DIVISION OF PURCHASES BID NO. 7550649

I-195 Relocation – Contract 16 – Providence River Pedestrian Bridge

NOTICE TO PROSPECTIVE BIDDERS

ADDENDUM NO. 3 Prospective bidders and all concerned are hereby notified of the following changes in the Plans, Specifications, Proposal and Distribution of Quantities for this contract. These changes shall be incorporated in the Plans, Specifications, Proposal and Distribution of Quantities, and shall become an integral part of the Contract Documents.

PROVIDENCE
IMPROVEMENTS TO
INTERSTATE ROUTE 195
CONTRACT 16 VOLUME 1
GRADING PLAN NO. 3

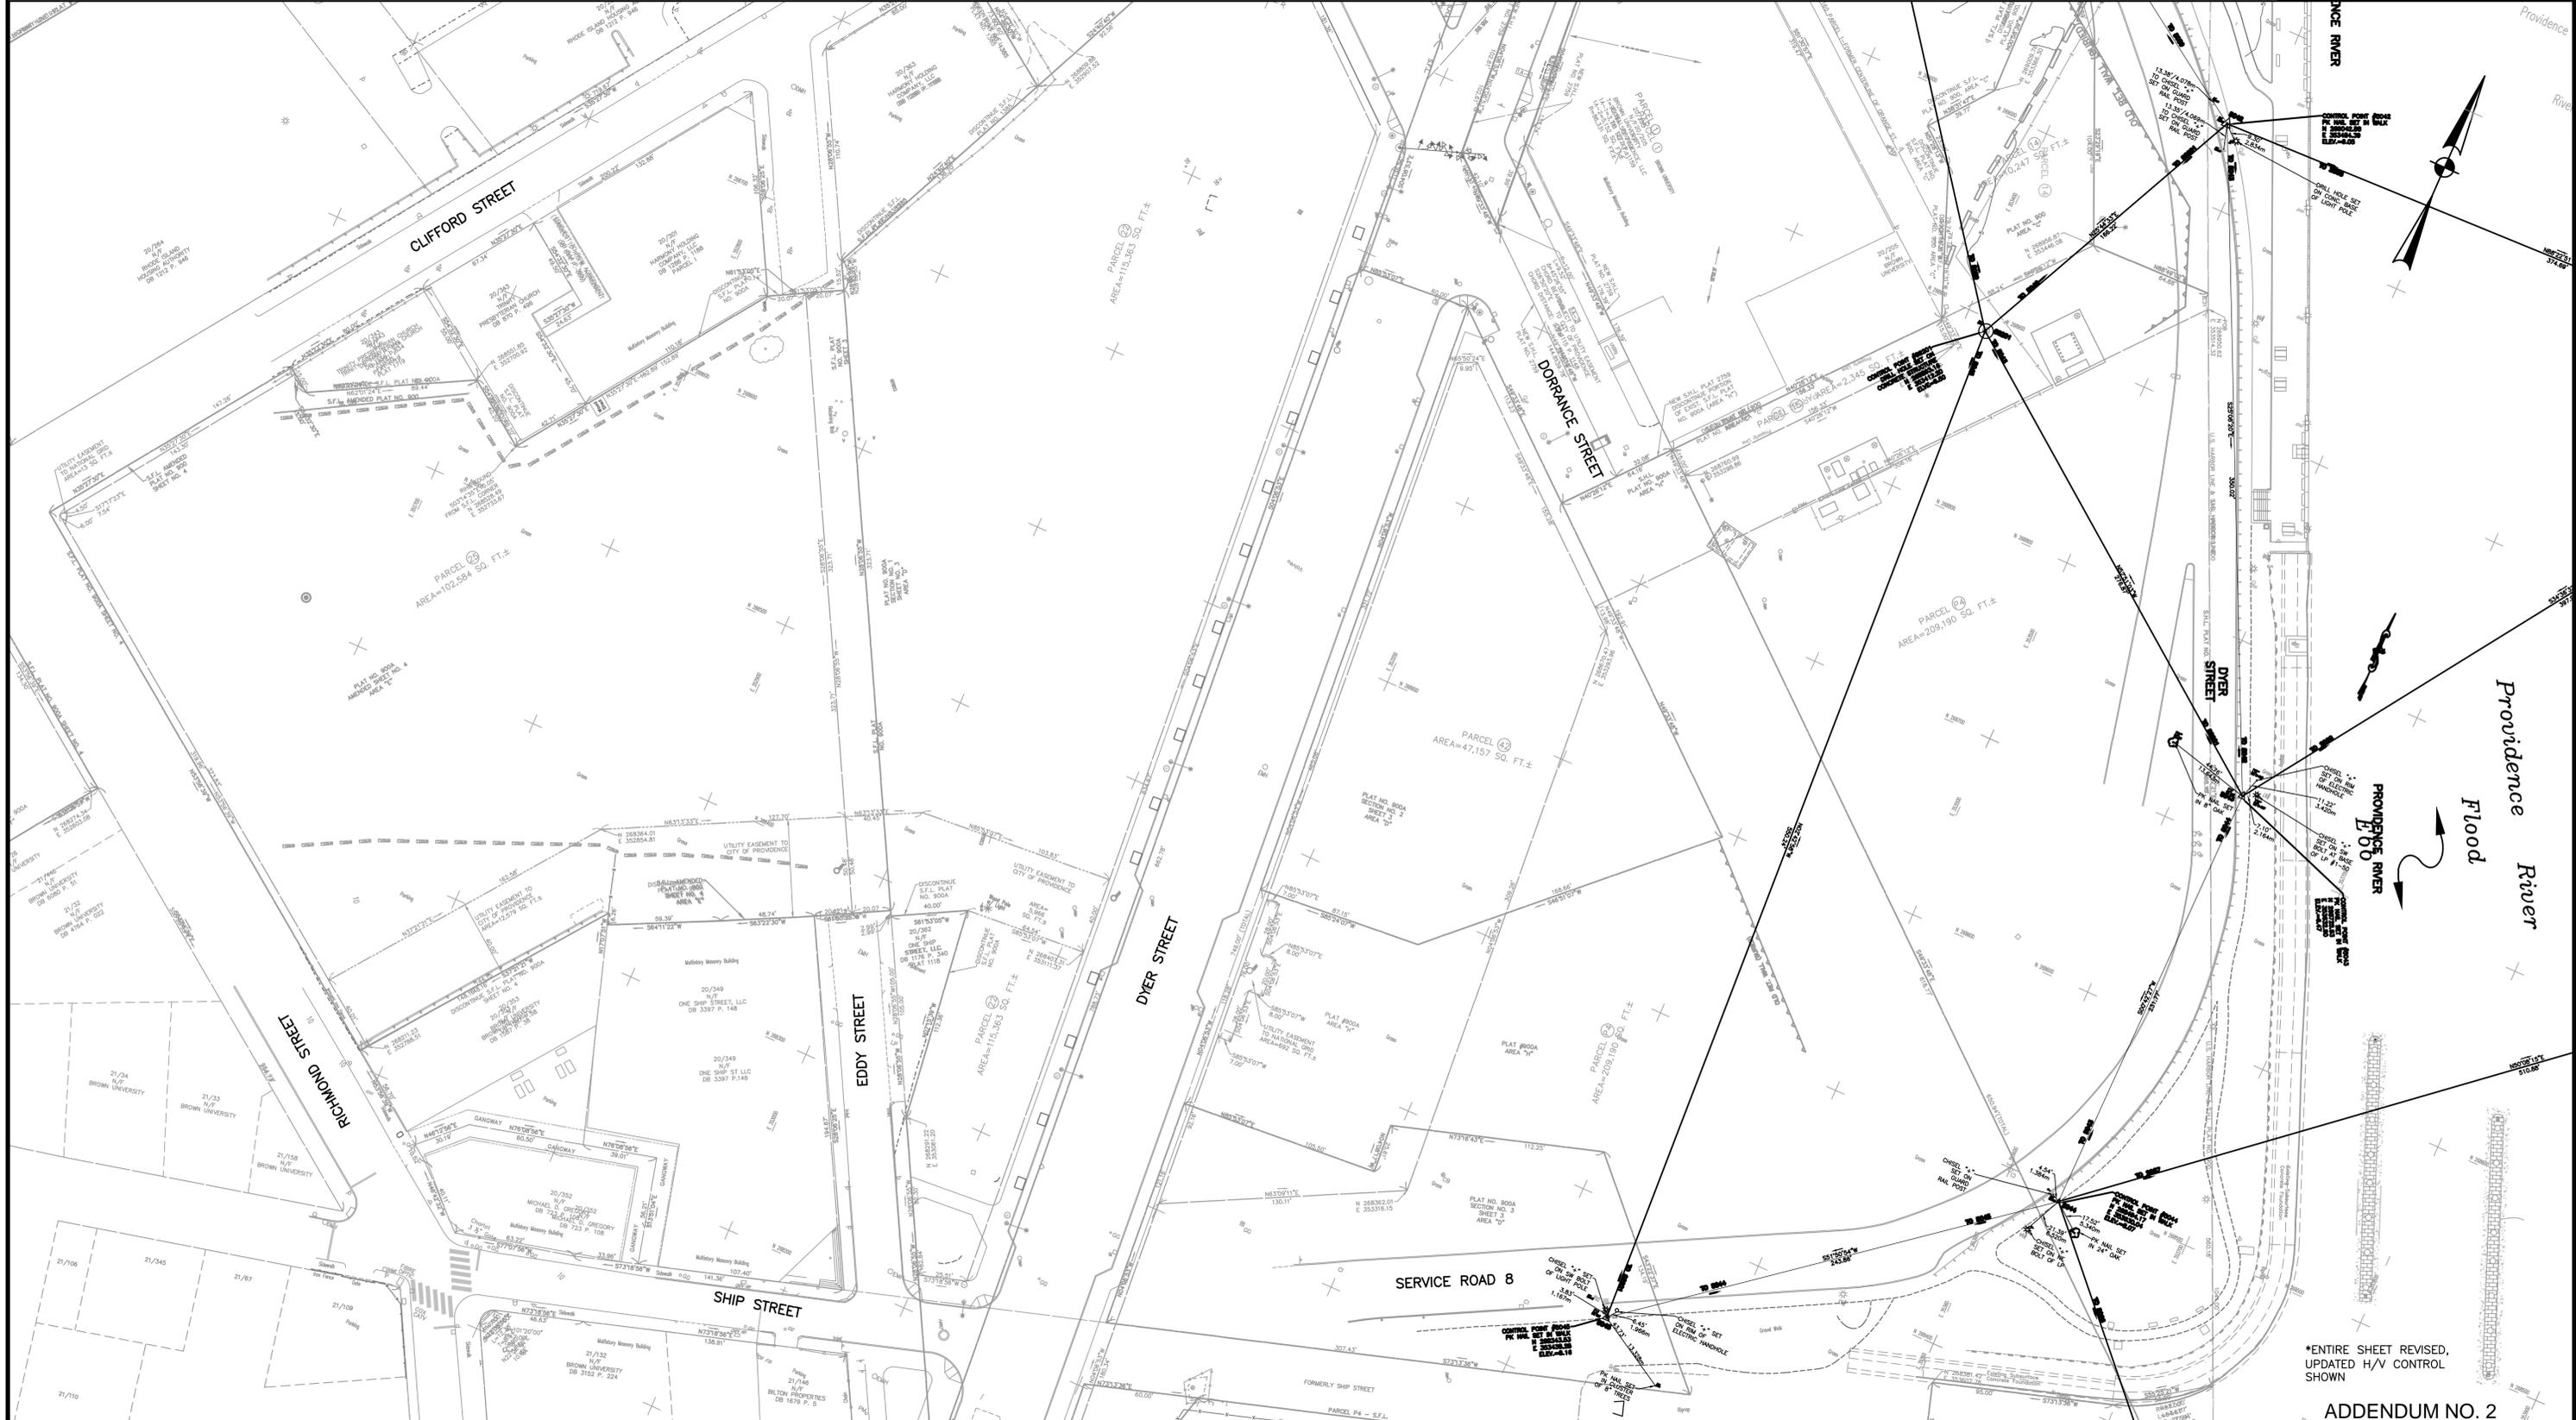
*ENTIRE SHEET REVISED, UPDATED H/V CONTROL SHOWN
 ADDENDUM NO. 2

PROVIDENCE
 IMPROVEMENTS TO
 INTERSTATE ROUTE 195
 CONTRACT 16 VOLUME 1
 HORIZONTAL/VERTICAL CONTROL
 PLAN NO. 1
 RHODE ISLAND

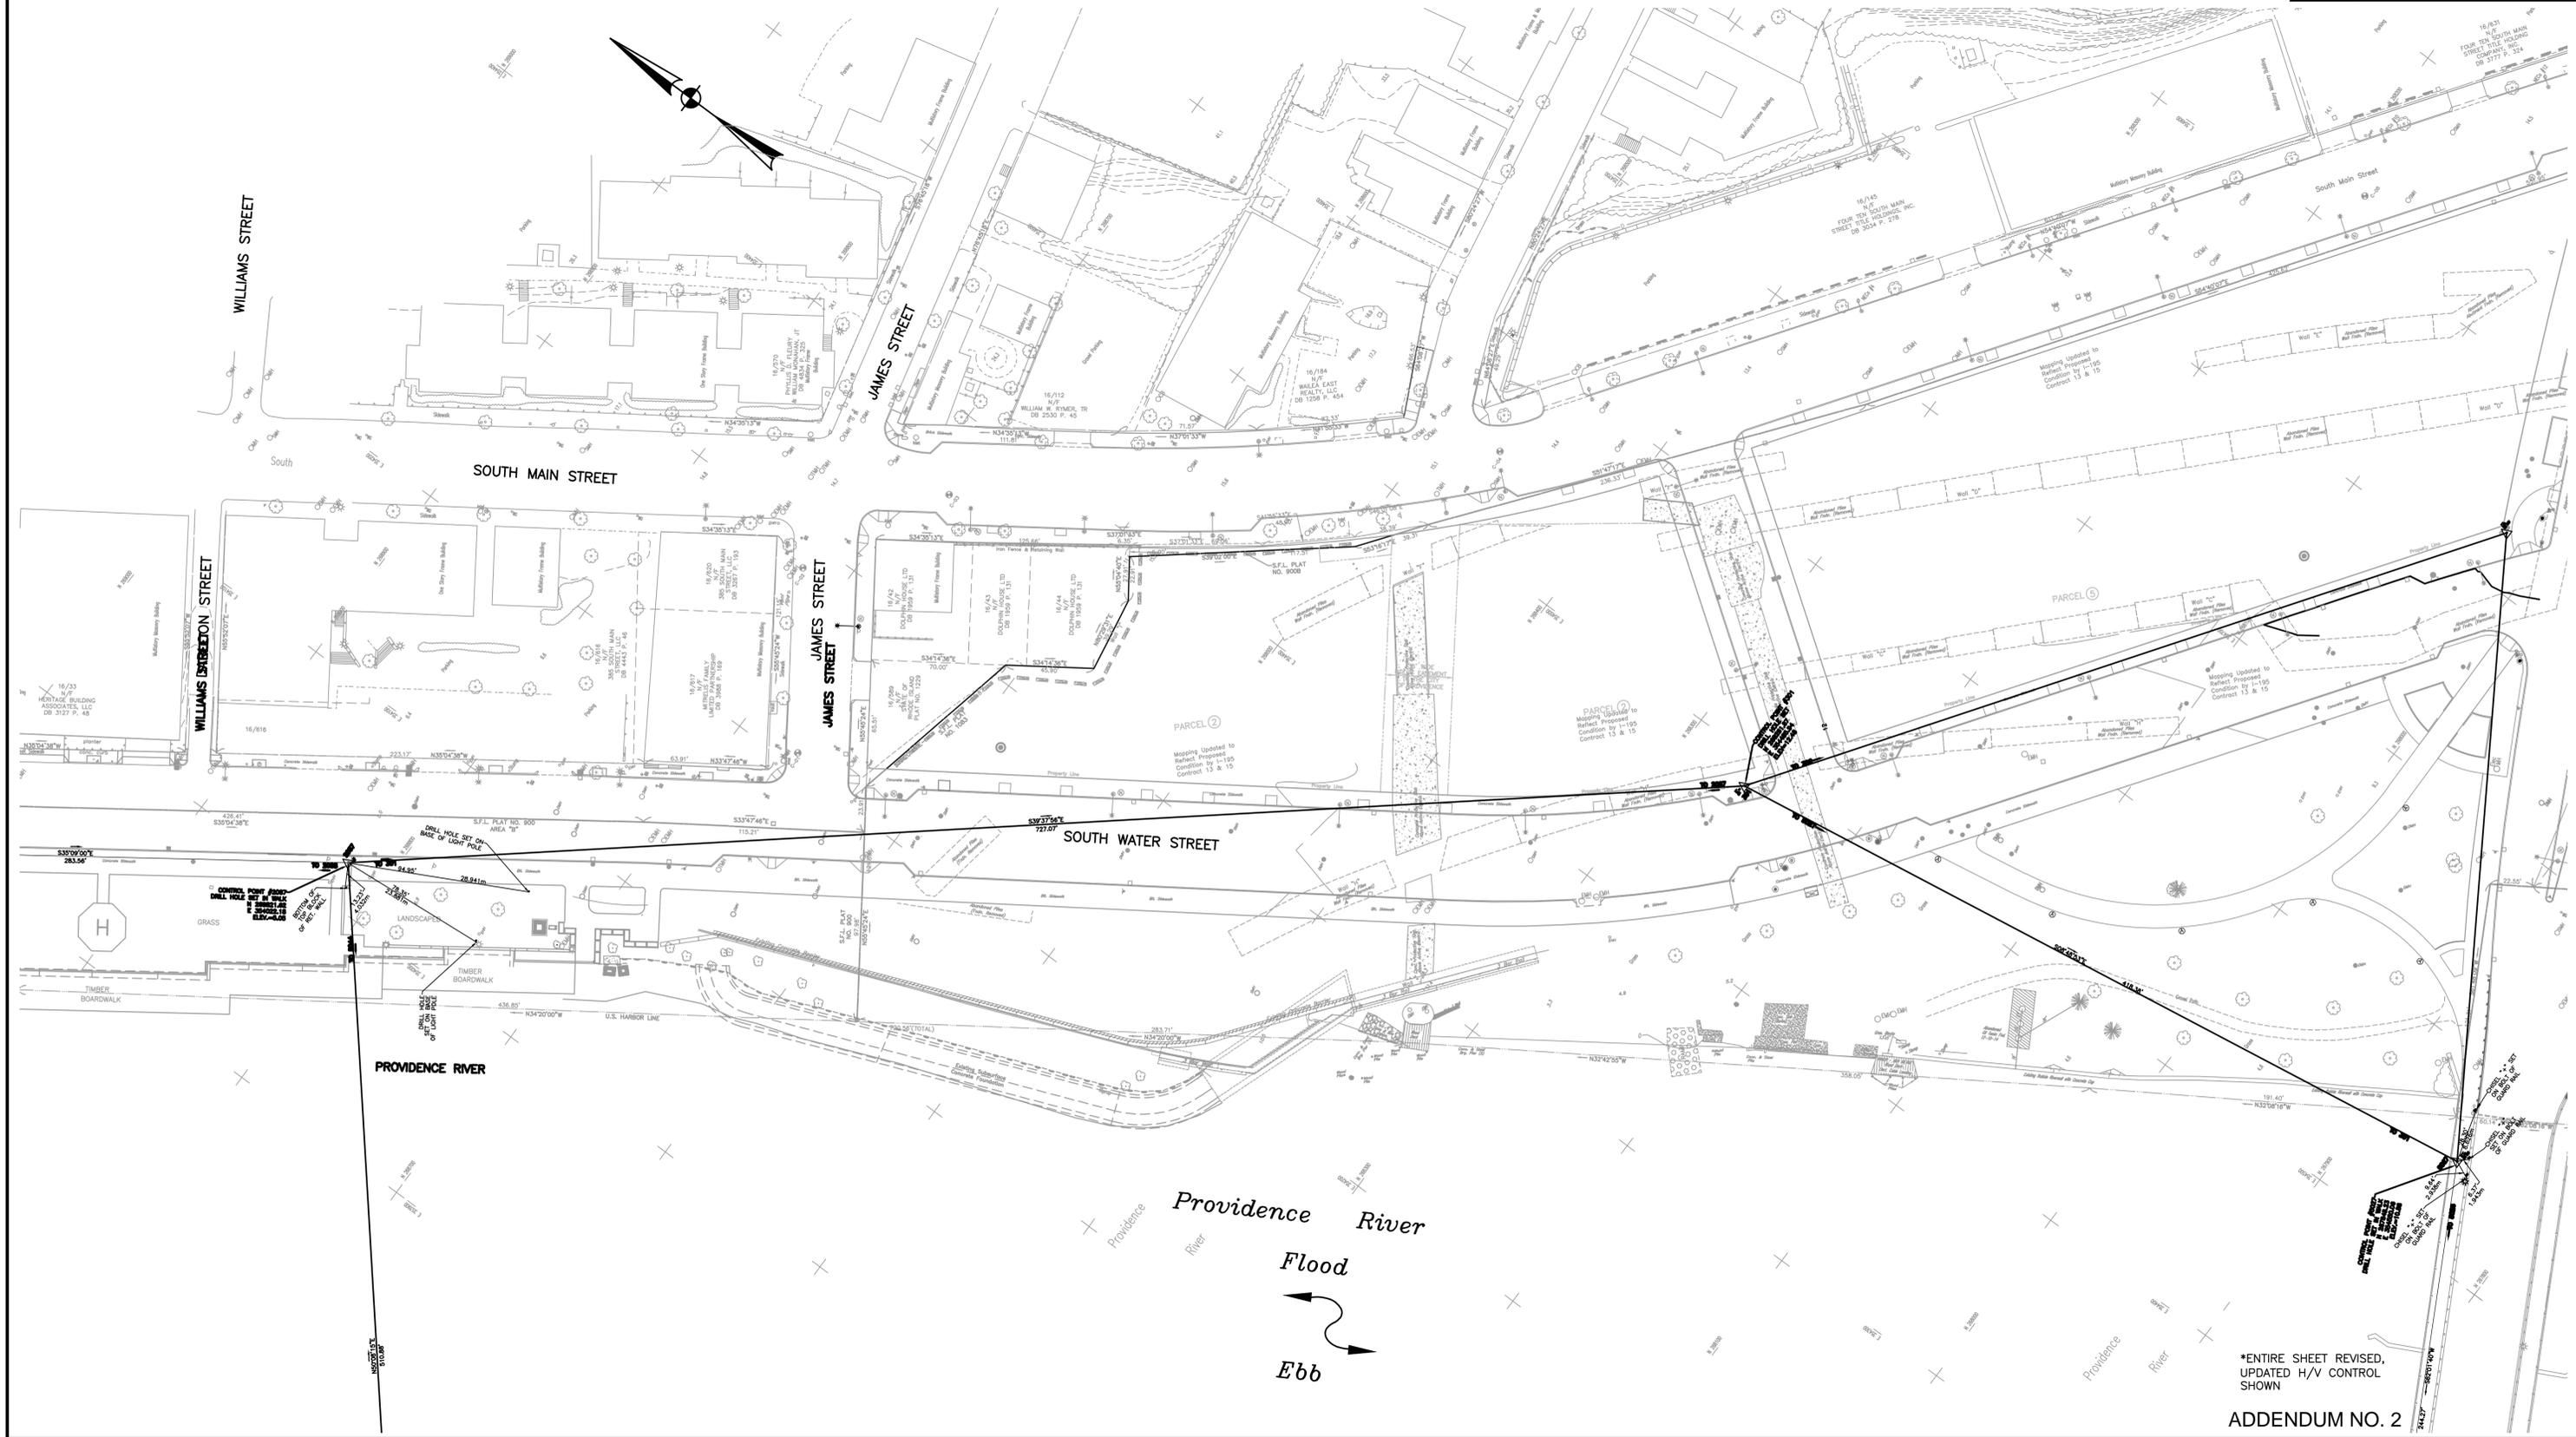
*ENTIRE SHEET REVISED, UPDATED H/V CONTROL SHOWN
 ADDENDUM NO. 2
